Product Change Notification: PCN-22-136405

8P Mod jack , SE

Bulk Package to Tray Package

Packaging Change from bag to Soft Tray for MODULAR JACK SIDE ENTRY, 8 POS

Photo

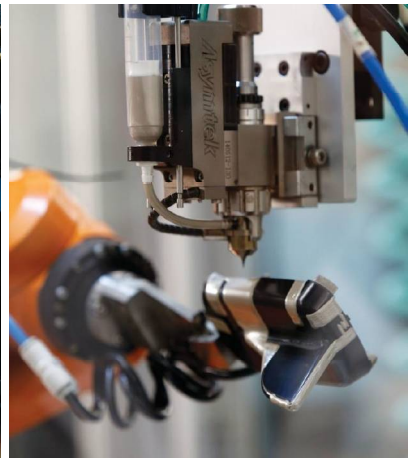
Pkg method: 210 pcs/bag x 6 =1260 Pcs/shipping box
 The detail packaging instruction is according to PS 107-107766 Rev A.
---Test result: There are no any products damaged and defect after drop test.
---The corner of shipping box impacted were distorted, but not damaged

Test Result: Passed Failed

0%, 0 pcs (NG) / 1260 pcs (OK) : 1 BOX
